#### **Non-Material Amendment Application**

Proposed Changes in relation to existing Planning Approval Ref: 2013/8192/P and clarifications of details as required under condition no. 3 with the exception of item 5 below.

University College London Hospitals			NHS	Scott Tallon Walker Architects		Proton Beam Therapy - Phase 4								
-	Designed by	Name Designer	Signature	Date	SCALE @ A1 As indicated	BIM FILE NAME	VIE - Facade Details - Non Material Amendment Application				rial			
	Drawn by	Author			FIRST ISSUE DATE	PROPOSED STATUS	PROJECT	ISSUER	AREA	LEVEL	TYPE	TRADE	SEQUENCE	REV
	Checked	Checker			22/06/15	S2 - Issued for information				SL	DET	A31	180090	$\mathbf{c}$
n	Approved	Approver			22/00/13		F4FDI	317	VIC	3L	DET	ASI	100090	C

## VIE - Detail Section - Door head 1-5 Non Material Amendment Application 1:5

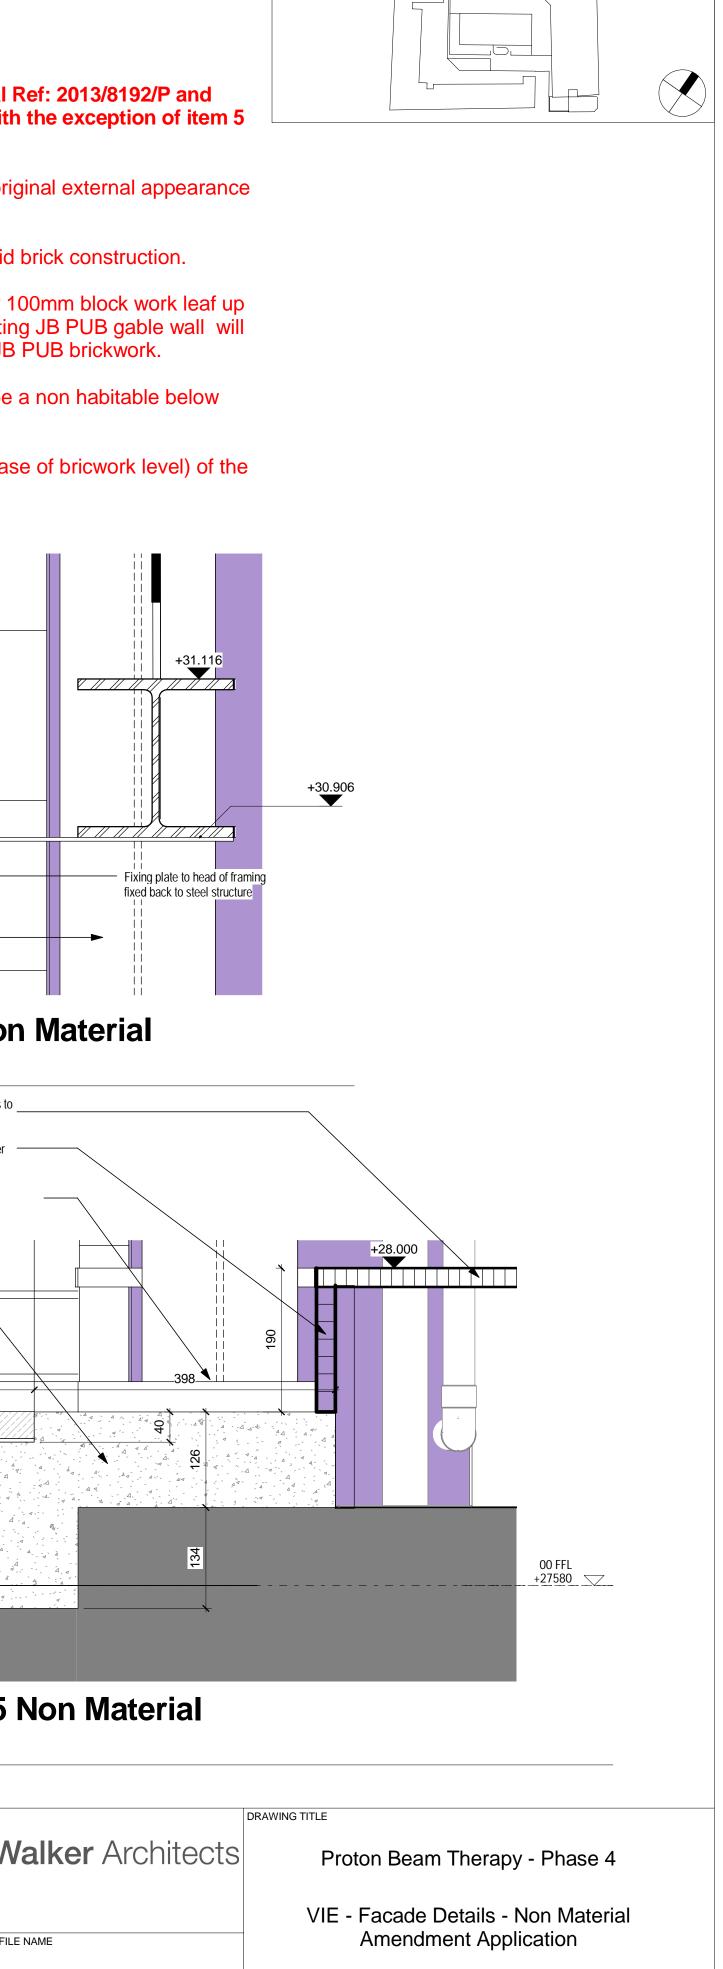
1. Base of the VIE enclosure to be reconstructed to replicate original external appearance of the Rosenheim building based on detailed surveys.

2. New brick enclosure may be constructed as a traditional solid brick construction.

3. Existing JB PUB gable wall to be externally clad with a new 100mm block work leaf up to VIE enclosure level. Above the VIE enclosure level the existing JB PUB gable wall will be externally clad with a new 100mm brickwork leaf to match JB PUB brickwork.

4. Undercroft level below proposed VIE ground floor slab will be a non habitable below ground chamber and will not be used for storage.

5. Final specification and details of the base (from ground to base of bricwork level) of the VIE enclosure will be subject to a further submission.
